8 October 2021

Submission – Tasman Highway to Midway Point Causeway

SCHEDULE ONE

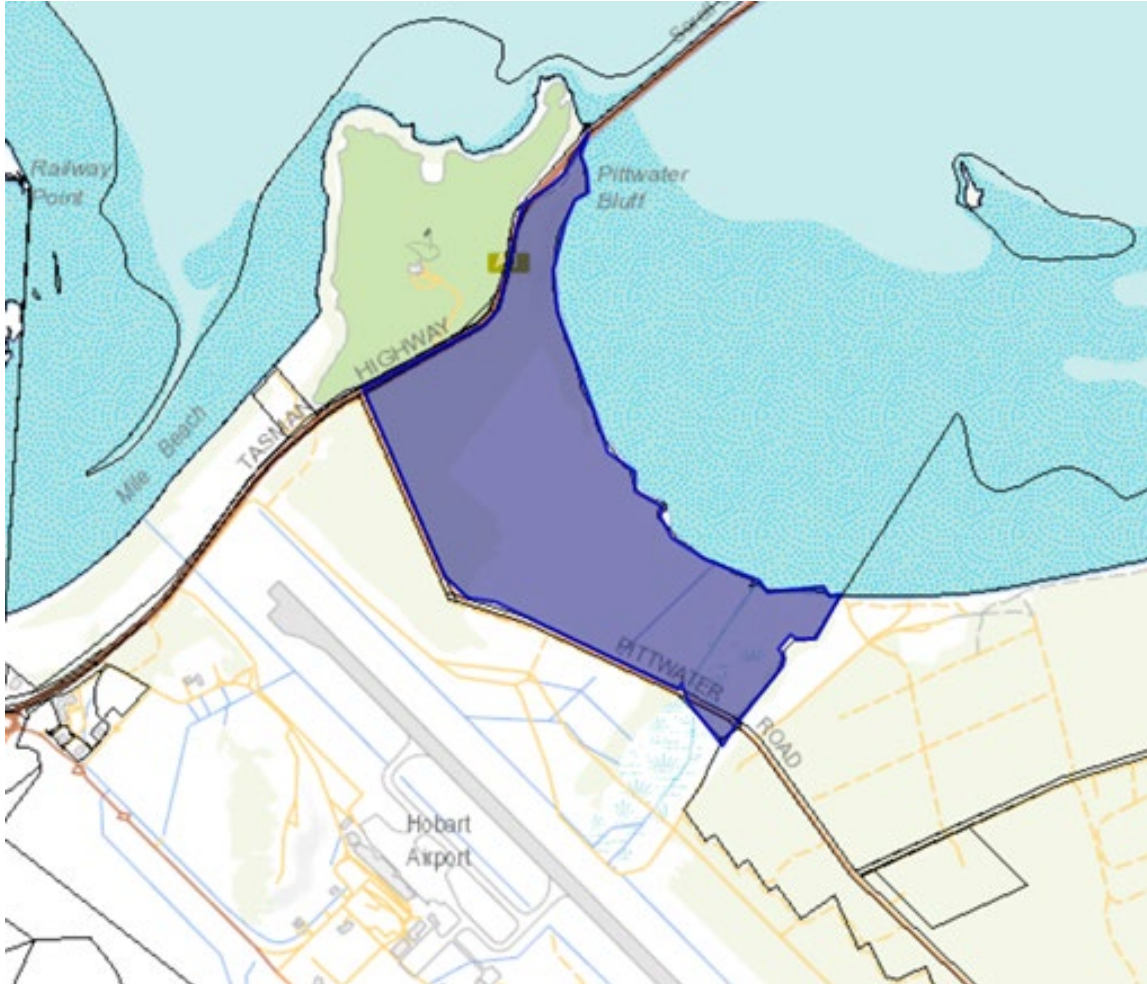
We write with particular reference to ‘Milford’, the property that is adjacent to the north-eastern boundary of the Hobart Precinct along Pittwater Road, located at 1431 Tasman Highway, Cambridge, TAS 7170 (**Milford**), also identified in Schedule One to this letter.

SCHEDULE TWO

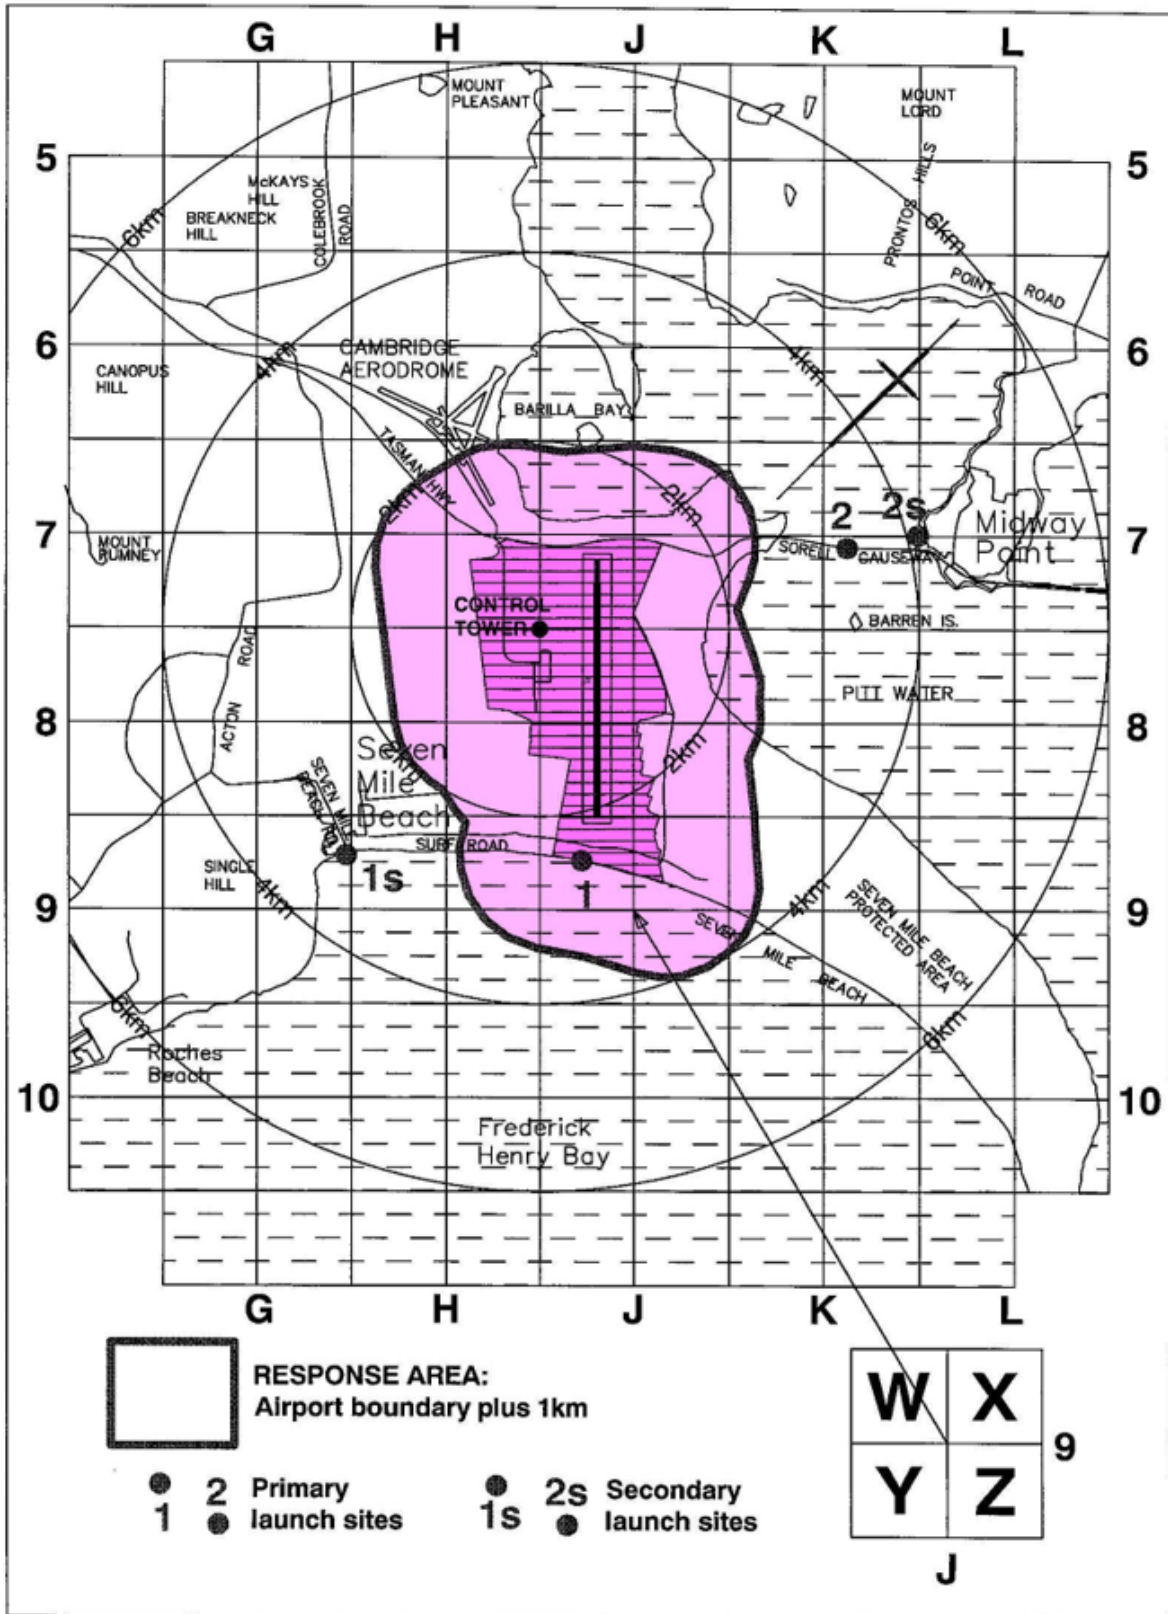
1. Milford is within Hobart Airport’s Off-Airport Emergency Response Area as shown in Schedule Two to this letter;
2. in the event of an aviation emergency affecting Milford, the Aviation Rescue Fire Fighting Service (**ARFF**), requires unimpeded road access to that property; and
3. as an entity with regulatory authority in respect of aviation and community safety, Hobart Airport is required to ensure that ARFF has adequate access from the Hobart Airport precinct to the Off-Airport Emergency Response Area.

SCHEDULE FOUR

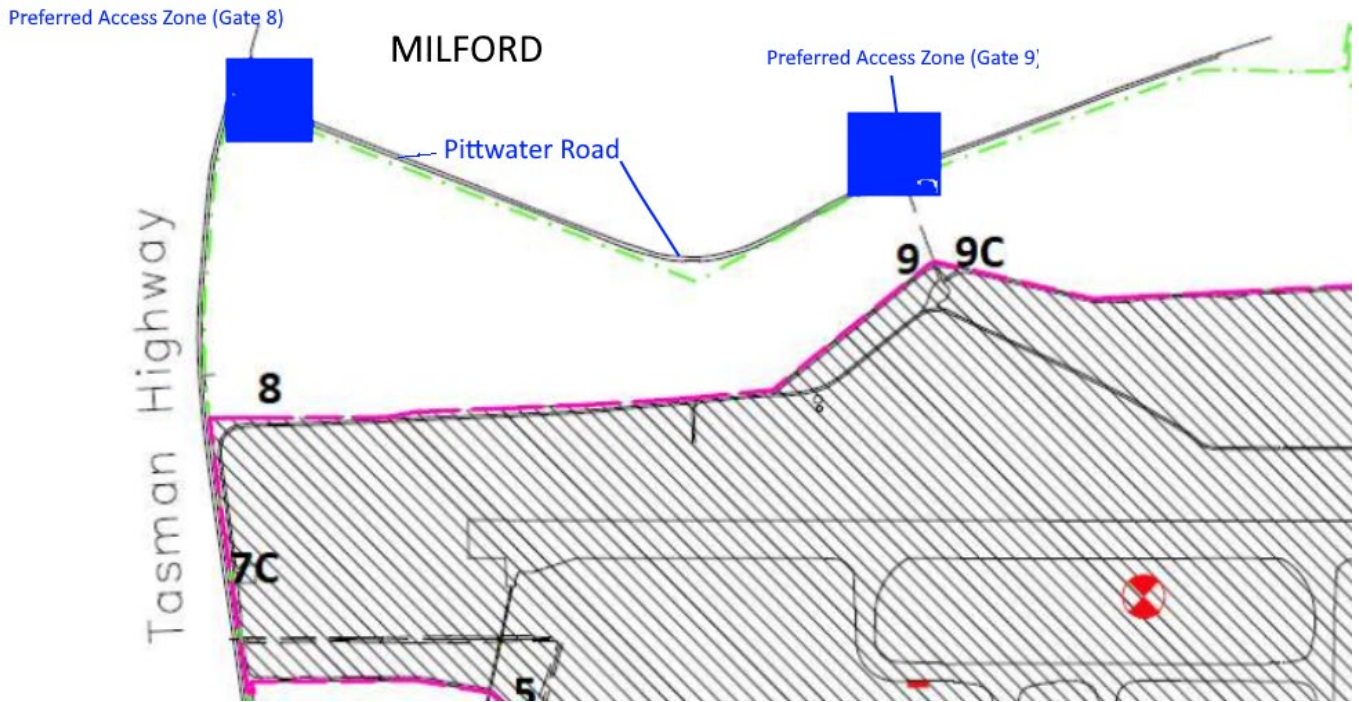
In order to ensure the best safety outcome for the local community, Hobart Airport advocates for the Committee to consider making a recommendation to the effect that the Department of State Growth provides ARFF with satisfactory direct access to Milford from Pittwater Road at a point that is opposite or adjacent to Hobart Airport's frangible gates (numbers 8 and 9 - the areas identified with a blue box as the 'Preferred Access Zones' in Schedule Four).
